Jones Gillam Renz Architects

Irving Lofts – Historic Rehabilitation – JGR Proj 25-3479

ADDENDUM NO. 1

CFP1

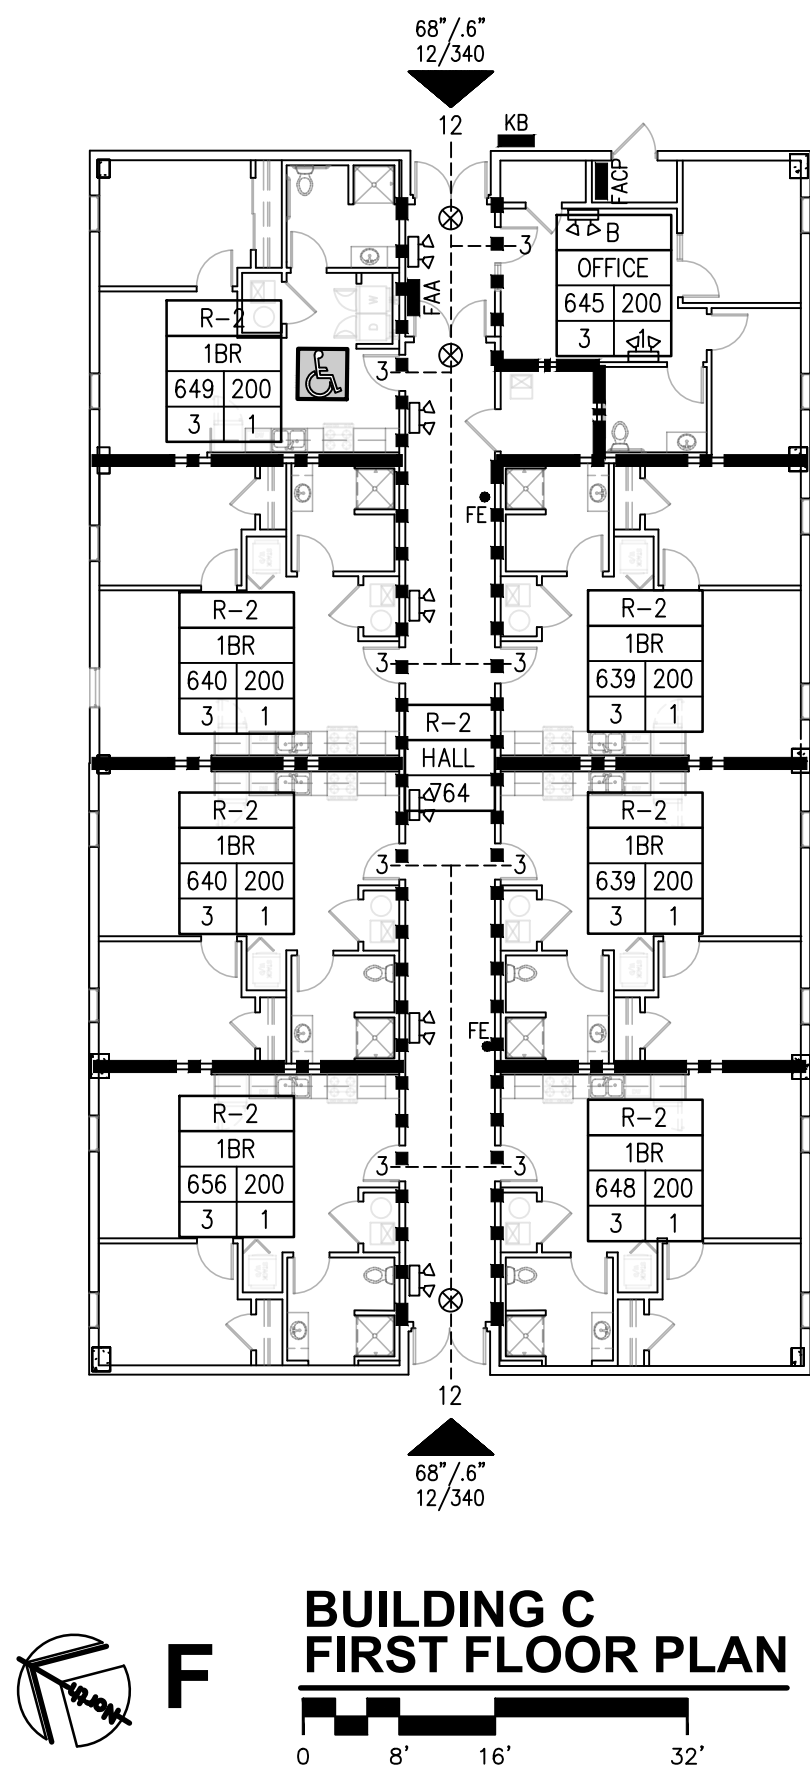
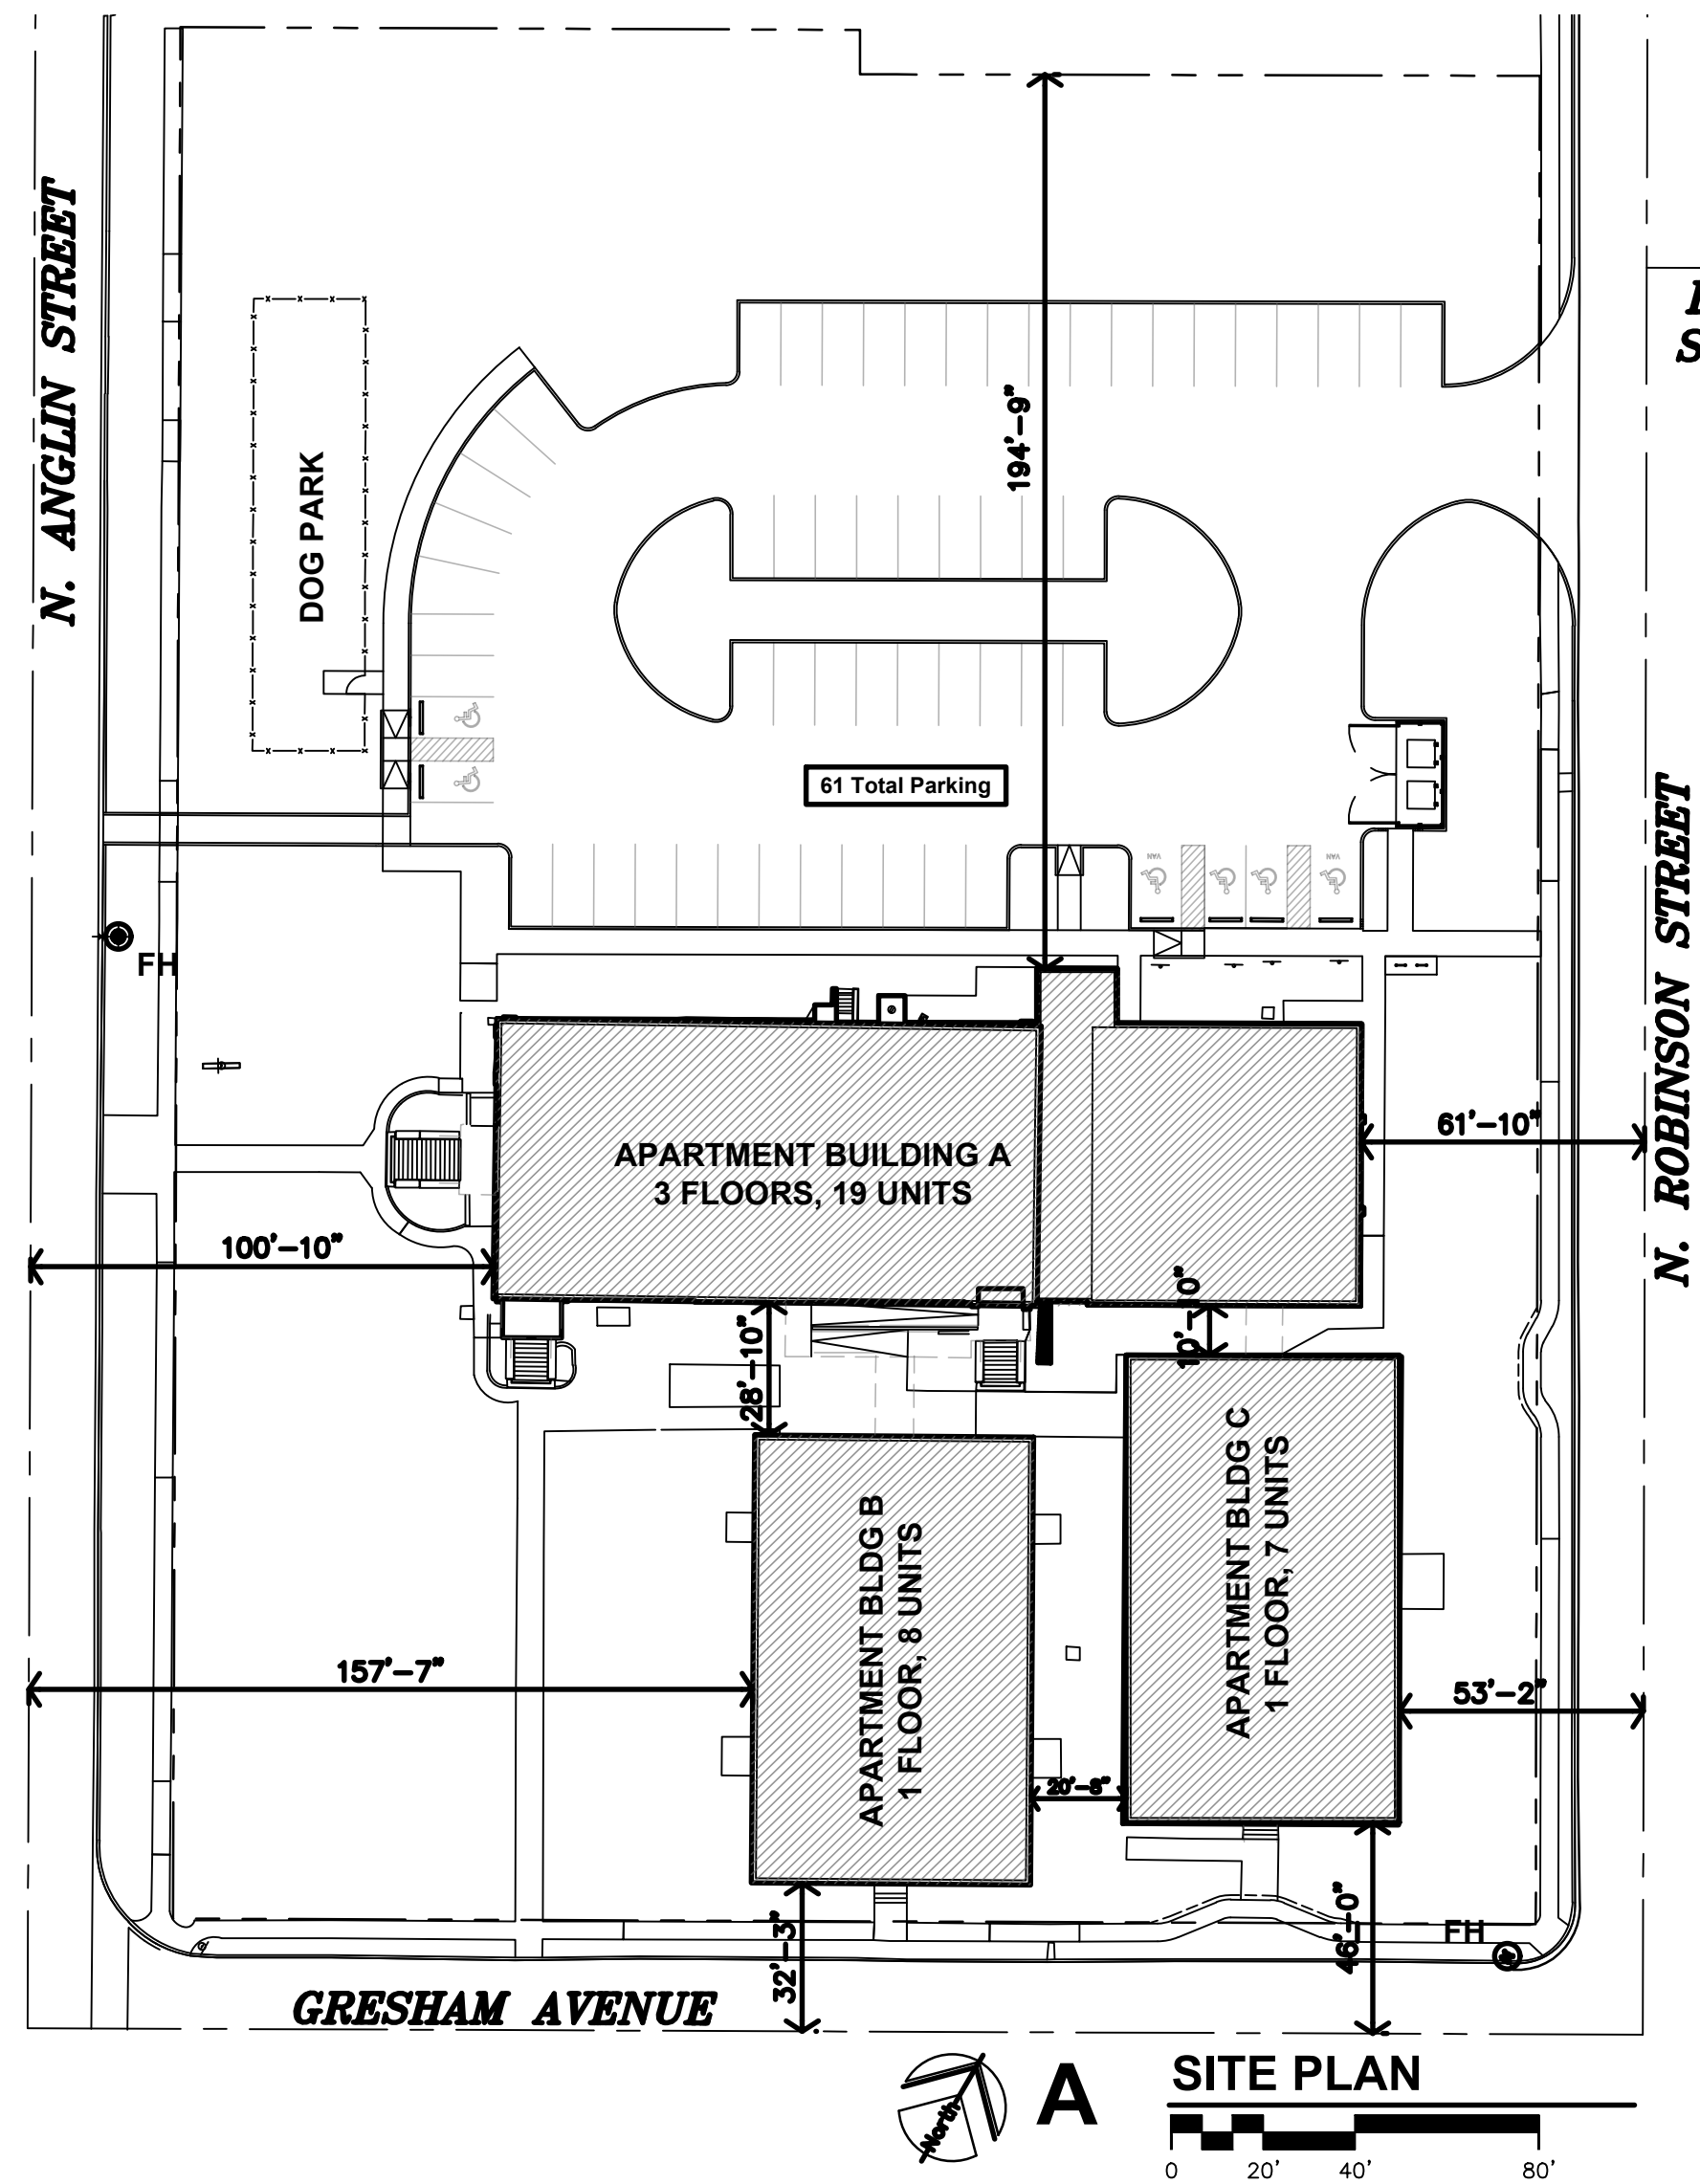
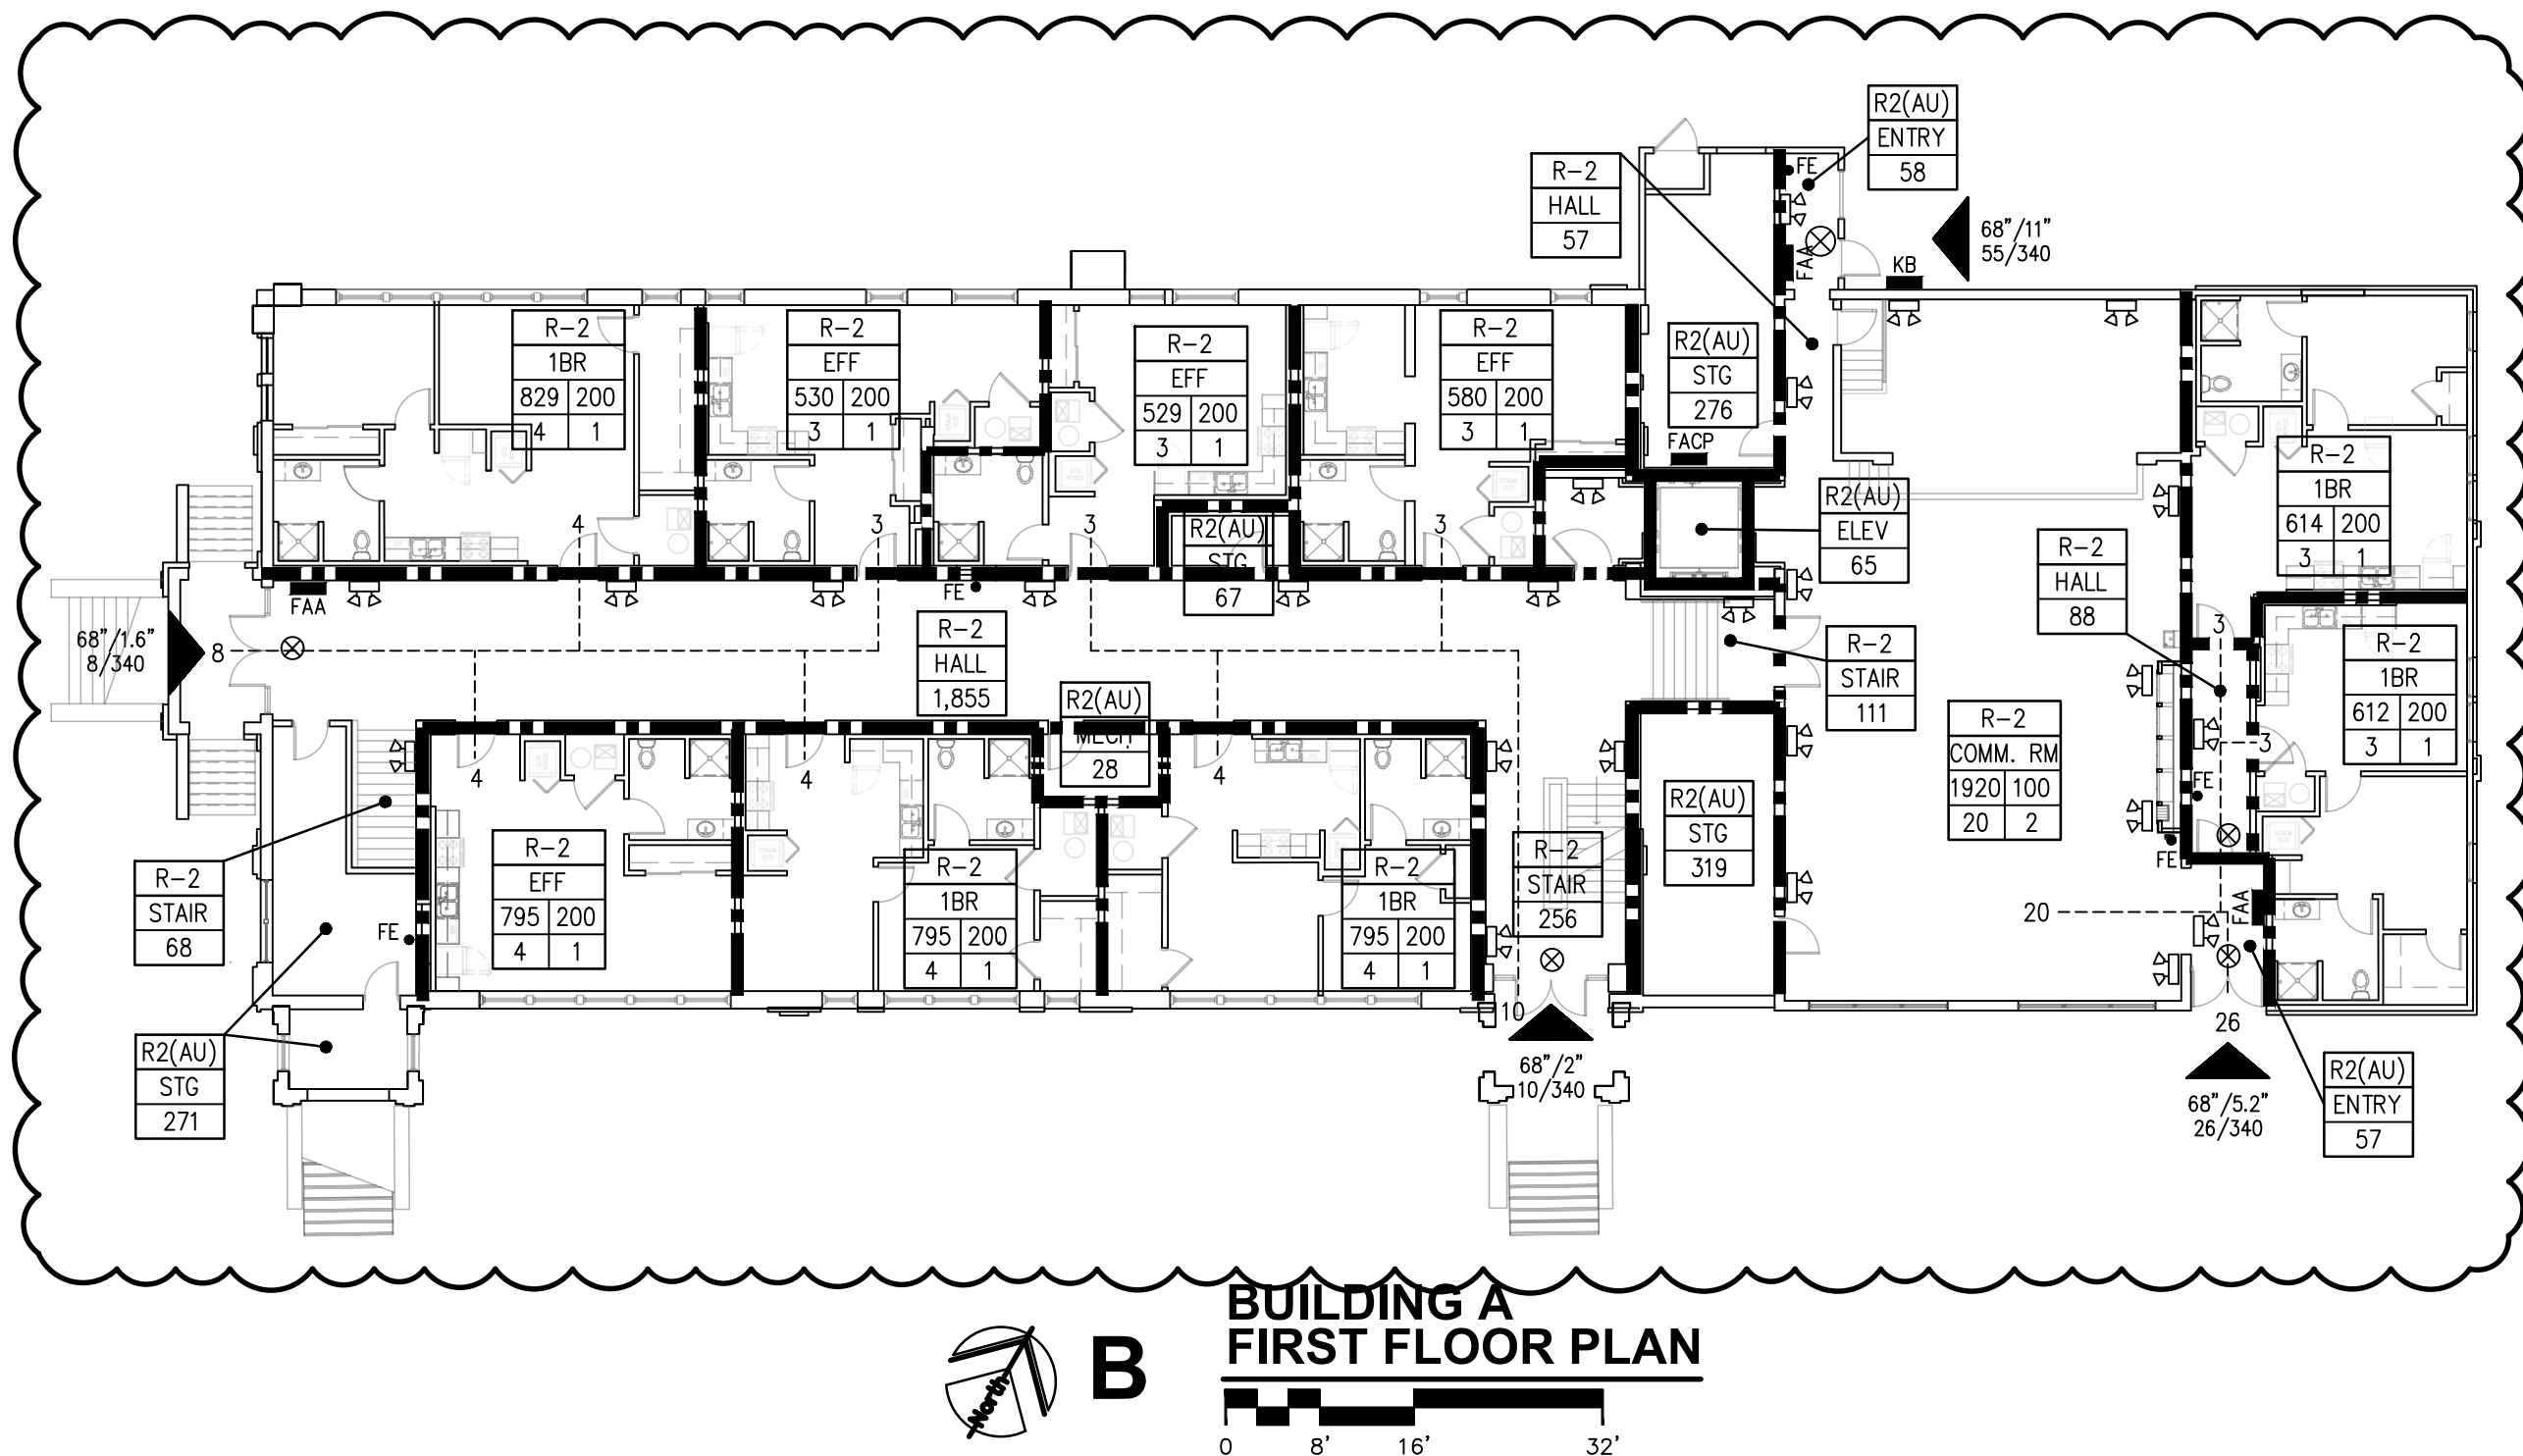
1. CFP1 – Building A: Construction Type has been revised to III-A in lieu of III-B. Allowable and actual building area have been revised. Basic allowable height has been revised. Fire Resistance Ratings and Construction chart has been revised.
